# PARTS & SERVICE NEWS

Ref. No.	AH00001
Date.	22.02.2000

**Subject:** Brake system – Brake oil tank

**Purpose:** Exchange of the brake oil tank at next visit of the machine

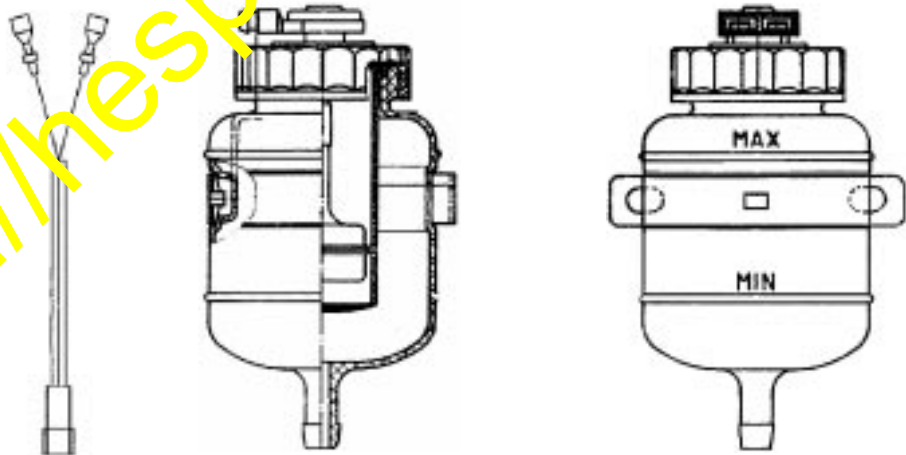
**Description:** In the further of technical development a new improved brake oil tank is mounted now on the above mentioned machines. At next visit of the machine the brake oil tank has to be exchanged. When changing the brake oil tank the current tank has to be removed including bracket. The new tank is supplied with a bracket.  
For the Wheel Loaders WA65-3 / WA65PT-3 / WA75-3 / WA85-3 an extension harness has to be fitted.  
Replace the label, if the new brake oil tank cover the current.

Name	P/N current	P/N new	Qty.
Tank	42U-43-17200	42U-43-17080	1
Extension harness	-----	42U-06-12670	1
Label	42U-93-11C80	42U-93-11C80	1

Name	P/N current	P/N new	Qty.
Tank	42U-43-17200	42U-43-17080	1
Label	42U-93-11C80	42U-93-11C80	1
